Service Bulletin

Bulletin No.: PI0924

Subject: Intermittent Unwanted Trunk Opening While Vehicle is Parked

Models: 2010-2013 Buick LaCrosse
2011-2013 Buick Regal
2012-2013 Buick Verano
2011-2013 Chevrolet Cruze
2012-2013 Chevrolet Sonic (4 Door Sedan Only)
2013 Chevrolet Malibu

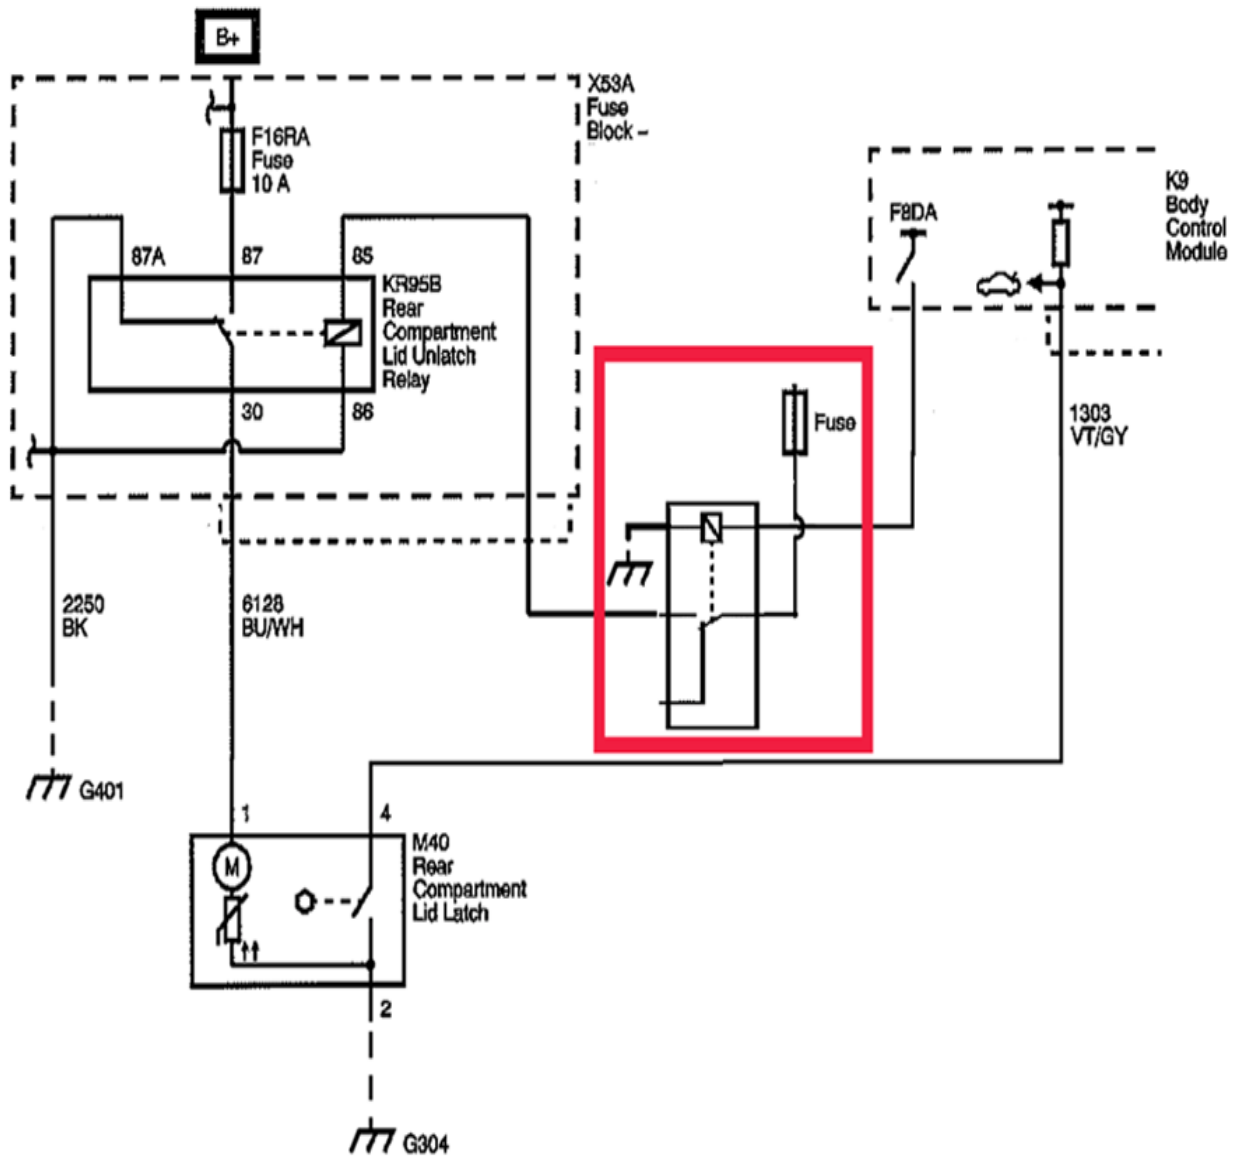
Replace the KR95B Rear Compartment Lid Unlatch Relay with a "Two Shot Relay", GM P/N 19119267, using the applicable procedure below. When installed, the remote transmitter (key fob) trunk release button, the exterior rear compartment lid release switch (touch pad) or the interior rear compartment lid release switch must be pressed twice within three seconds to release the trunk.

Remove the KR95B Rear Compartment Lid Unlatch Relay located in the X51A Instrument Panel Fuse Block and install the "Two Shot Relay."

3329904

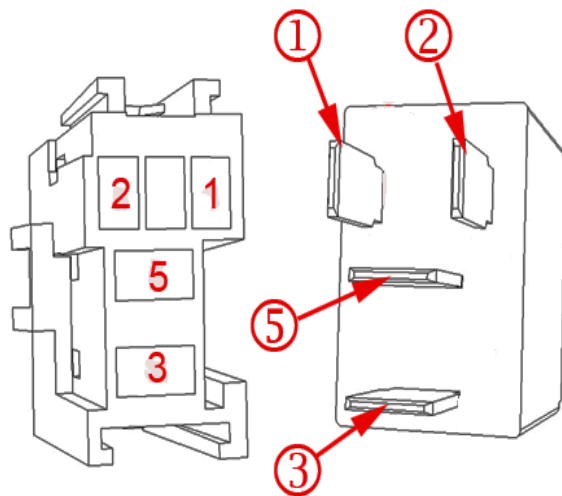
The rear compartment lid unlatch relay is part of the printed circuit board in the relay/fuse block and not serviceable separately. Installation of an external relay circuit to bypass the feed to the trunk release control will be required. Install the "Two Shot Relay" adjacent to the BCM and attach a tag to the relay and mark with "Two Shot Trunk Relay per Bulletin PI0924." For future diagnosis for an inoperative trunk release, this relay installation will be identified before a BCM is replaced.

1. Label the four leads of connector, P/N 12126045 as indicated below.
2. Connect the connector to the new relay, P/N 19119267.
3. Locate circuit 6188 (trunk release control) at the BCM following service information. Cut the wire and splice the BCM and relay side of the circuit as shown below.
4. Connect wire fused, unswitched power and ground as shown below.
